Access Compliance Report

Public Rights-of-Way

Intersection ID: 54374	Main Street: GRIER_RD	Cross Street: OLD_CONCORD_RD	Location: S
ADA ID: 7B71A0742DAD	Ramp Type: Perp	Initial Pass/Fail: Fail	Overall Compliance: No
Severity Score: 10			
Codes/Mitigation Info/Possible Solution		Field Measurements/Component Compliance

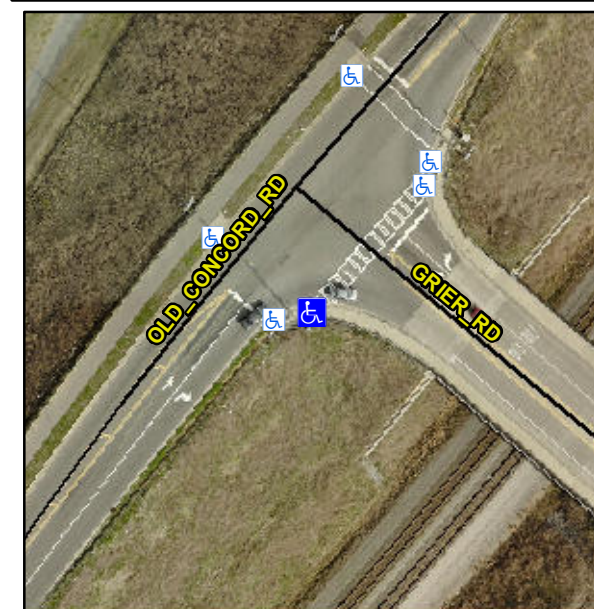
Remove & Replace Entire Ramp.

R304.5.1, R304.5.3

Compliance	Description	Data	Compliance	Description	Data
N/A	Ramp Length (in)	83.5	Yes	Ramp Slope (%)	6.3
No	Ramp Width (in)	47.0	No	Ramp XSlope (%)	2.5
N/A	Flare Type LT	N/A	N/A	Flare Type RT	N/A
N/A	Flare Slope LT (%)	N/A	N/A	Flare Slope RT (%)	N/A
N/A	Flare Traversable LT?	N/A	N/A	Flare Traversable RT?	N/A
N/A	Landing Length (in)	N/A	N/A	DWS Provided?	N/A
N/A	Landing Width (in)	N/A	N/A	DWS Contrast?	N/A
N/A	Landing Slope (%)	N/A	N/A	DWS Length (in)	N/A
N/A	Landing X Slope (%)	N/A	N/A	DWS Full Width?	N/A
N/A	Landing Curb? (Y/N)	N/A	N/A	DWS Offset (in)	N/A
N/A	Shared Landing?	N/A			
N/A	Gutter Ponding?	N/A	N/A	Gutter Slope (%)	N/A
N/A	Gutter Lip Ht (in)	N/A	N/A	Gutter X Slope (%)	N/A
N/A	Painted X Walk1?	Yes	N/A	Painted X Walk2?	N/A
	X Walk 1 Direction	To NE		X Walk 2 Direction	N/A
N/A	X Walk 1 Width (in)	104.0	N/A	X Walk 2 Width (in)	N/A
	X Walk 1 Slope (%)	1.0		X Walk 2 Slope (%)	N/A
	X Walk 1 X Slope (%)	0.3		X Walk 2 X Slope (%)	N/A
